# Access Compliance Report

## Public Rights-of-Way

### (Curb Ramps)

Intersection ID: N/A	Main Street: NATIONAL_AV	Cross Street: CITY_PARK_DR	Location: E
ADA ID: 1908A3E42BAD	Ramp Type: Perp	Initial Pass/Fail: Fail	Overall Compliance: No
Severity Score: 1.25			
Codes/Mitigation Info/Possible Solution		Field Measurements/Component Compliance

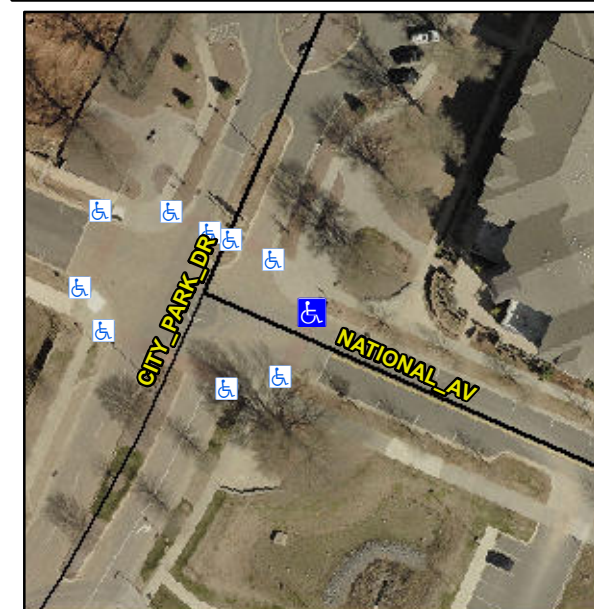
**Not Found, R304.5.3**

Compliance	Description	Data	Compliance	Description	Data
N/A	Ramp Length (in)	97.0	Yes	Ramp Slope (%)	6.7
Yes	Ramp Width (in)	74.0	No	Ramp XSlope (%)	2.4
N/A	Flare Type LT	N/A	N/A	Flare Type RT	N/A
N/A	Flare Slope LT (%)	N/A	N/A	Flare Slope RT (%)	N/A
N/A	Flare Traversable LT?	N/A	N/A	Flare Traversable RT?	N/A
N/A	Landing Length (in)	N/A	N/A	DWS Provided?	N/A
N/A	Landing Width (in)	N/A	N/A	DWS Contrast?	N/A
N/A	Landing Slope (%)	N/A	N/A	DWS Length (in)	N/A
N/A	Landing X Slope (%)	N/A	N/A	DWS Full Width?	N/A
N/A	Landing Curb? (Y/N)	N/A	N/A	DWS Offset (in)	N/A
N/A	Shared Landing?	N/A			
N/A	Gutter Ponding?	N/A	N/A	Gutter Slope (%)	N/A
N/A	Gutter Lip Ht (in)	N/A	N/A	Gutter X Slope (%)	N/A
N/A	Painted X Walk1?	Yes	N/A	Painted X Walk2?	N/A
	X Walk 1 Direction	To SW		X Walk 2 Direction	N/A
N/A	X Walk 1 Width (in)	98.0	N/A	X Walk 2 Width (in)	N/A
	X Walk 1 Slope (%)	3.8		X Walk 2 Slope (%)	N/A
	X Walk 1 X Slope (%)	2.1		X Walk 2 X Slope (%)	N/A

**Remove & Replace Entire Ramp.**
